**BUILDING
INNOVATIONS
AUSTRALIA**

ADAPTABLE HOUSING & LHDG INDICATIVE COMPLIANCE REPORT FOR SSDA LODGEMENT

**65 Muston Street,
Mosman NSW 2088**

Prepared for:	Prosper Property Pty Ltd
Project No.:	PRO-10056-G1P6
Date:	20/02/2026
Status:	Report Issue v1.2

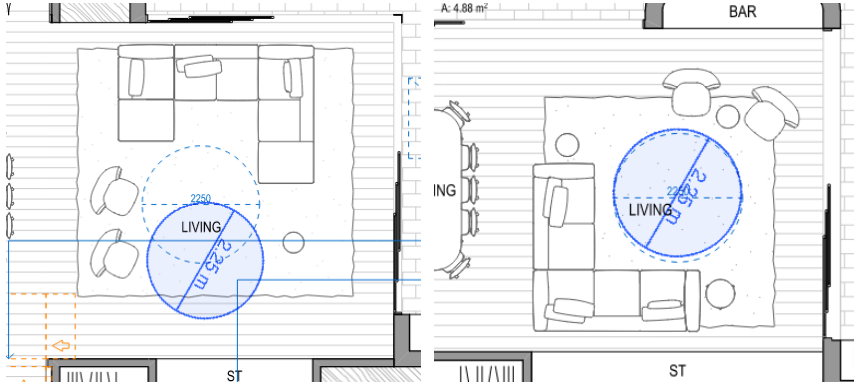
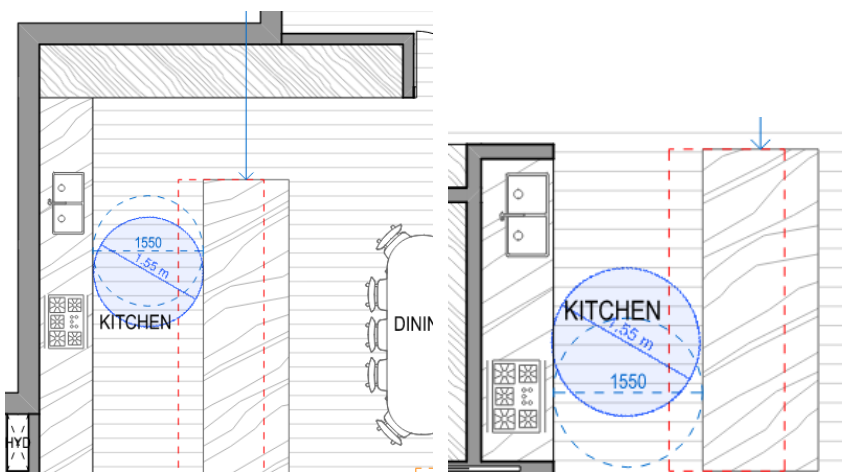
Item	Status	Item Description	References
34	CRA	Provision for compliance with AS 1428.1 for door approaches  AS 1428.1-2009 FIGURE 31 (in part) CIRCULATION SPACES AT DOORWAYS WITH SWINGING DOORS FIGURE 31 (in part) CIRCULATION SPACES AT DOORWAYS WITH SWINGING DOORS Internal corridors shall have a minimum width of 1000 mm. After adaptation, circulation spaces at doorways shall comply with AS 1428.1. Provision for doorway approach circulation spaces for the main toilet and common facilities to comply with AS 1428.1-2021 with minimum 820mm clear door width as allowed by Item 32 for the subject units at post-adaptation as illustrated below, with the exception of numerous doorways within Units 401 & 501: 	Clause 4.3.7 - Internal Corridors

Recommendation: Compliance can be achieved via slight redesign prior to the issue of the Construction Certificate.

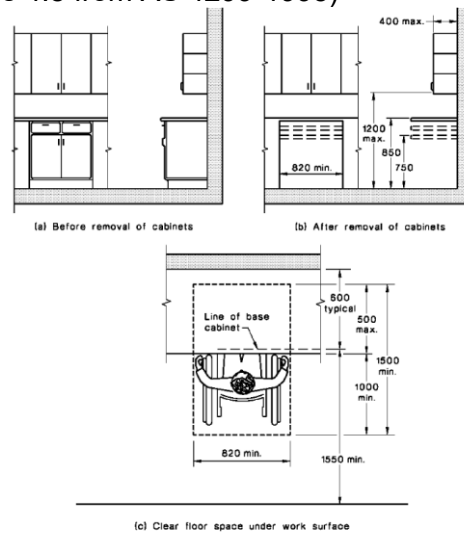
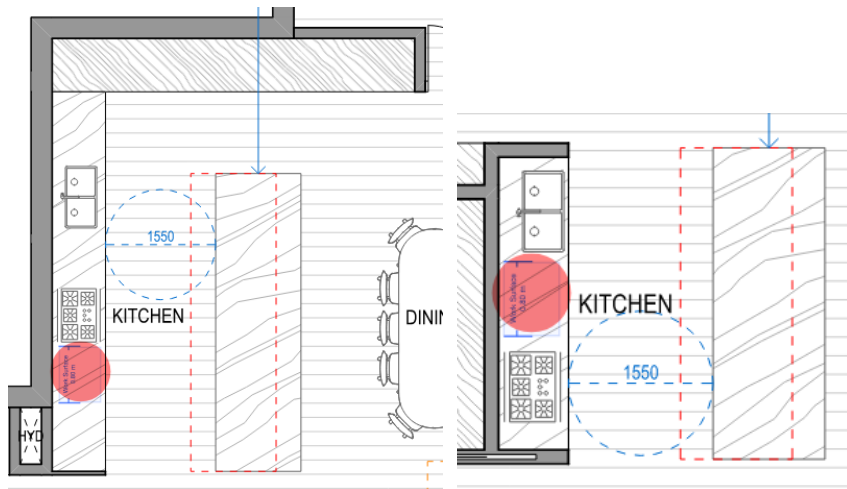
As illustrated below, the subject units have provision for not less than one worksurface:

Recommendation: positioning fridge 800mm from cooktop/oven combo to provide all 4 items in one workspace location. Compliance can be achieved via slight redesign prior to the issue of the Construction Certificate.

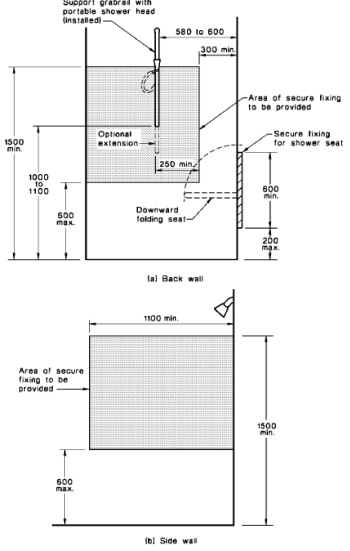
Post adaptive fixtures and circulation spaces are to comply with the required dimensions of AS1428.1-2021 (blue) or element(s) requiring review (red) for the designated units:

Bathroom			
Item	Status	Item Description	References
		Recommendation: Compliance can be achieved via slight redesign prior to the issue of the Construction Certificate.	
76	CRA	Slip-resistant floor surface <i>Floor surfaces shall be slip-resistant to comply with AS/NZS 3661.1.</i> Note to be added to plans prior to issue of the Construction Certificate. Design verification to be provided prior to the issue of the Construction Certificate.	Clause 4.4.2 - Floor Surface
77	CRA	Shower recess-no hob. Minimum size 1160 x 1100mm to comply with AS 1428.1 (Refer to Figures 4.6 and 4.7 of AS 4299-1995)   Shower compartment A shower shall be provided. The shower compartment shall be a minimum size of 1160 x 1100 mm. The soap holder shall be recessed. The position of the shower head and taps shall be such that the clearances and heights required by AS 1428.1 are achieved. Provision for this item appears to be indicated on the post-adaption plans as illustrated in Item 75.	Clause 4.4.4(f) - Shower Compartment

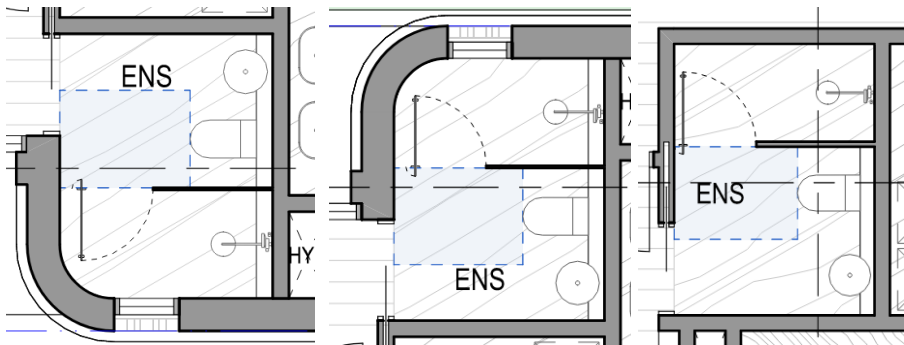
Toilet circulation space of 900mm x 1200mm in front of toilet pan, clear of obstacles or door swings has been provided, as illustrated in the examples below:

Recommendation: In some cases, it is highly preferable for toilet to be located in corner to enable installation of grabrails at a future date, however the rear wall between the toilet and shower screen must be reinforced to support drop down grabrails. Compliance can be achieved via slight redesign prior to the issue of the Construction Certificate.
